95.8.5 Transmitter vertical eye closure (TxVEC)

95.8.5.1 TxVEC conformance test set-up

95.8.5.2 TxVEC measurement method

Figure 95-4—Illustration of the TxVEC measurement

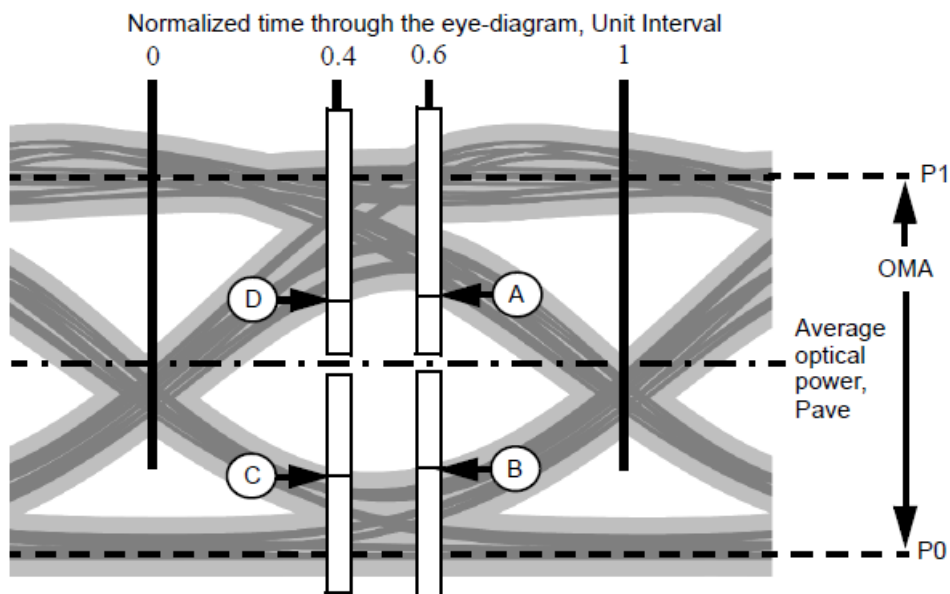
In Figure 95-4, delete the round labels and arrows A, B, C, D. The values of P1 and P2 are not used in the calculation; they could be deleted if desired

$P1$ $P0$ _[PD1] OMA ~~C-D-A-B~~

OMA is measured according to 95.8.4. ~~The power of the optical zeros (P0) and the power of the optical ones (P1) are recorded.~~ [Also the standard deviation of the noise of the oscilloscope, S, is found with no input optical signal and the same settings as used to capture the histograms described below.](#)

Each histogram window has a width of 0.04 UI. Each histogram window has one height boundary set close to the average power level P_{ave} of the eye-diagram, and the other height boundary is set beyond the outer-most samples of the eye, so that no further eye samples would be captured by increasing the outer boundary of the histogram. ~~Starting from the boundary of the histogram closest to the average optical power level, the optical power at which the cumulative distribution of each histogram equals the 0.005th percentile of the total number of samples for each histogram is recorded (these are the powers A, B, C, and D illustrated in Figure 95-4).~~

The two histograms on the left are each convolved with a Gaussian function with a standard deviation A so that the sum of the portion of the resulting upper distribution below P_{ave} plus the portion of the resulting lower distribution above P_{ave} is 5×10^{-5} of the total of both distributions. Similarly, the two histograms on the right are each convolved with a Gaussian function with a standard deviation B so that the sum of the portion of the resulting upper distribution below P_{ave} plus the portion of the resulting lower distribution above P_{ave} is 5×10^{-5} of the total of both distributions. Both Gaussian functions have a mean of zero.

$$R^2 + M^2 = N^2 + S^2 \quad (95-1)$$

$$\text{TxVEC} = 10\log_{10}(OMA / (2Qmin R)) \quad (95-3)$$
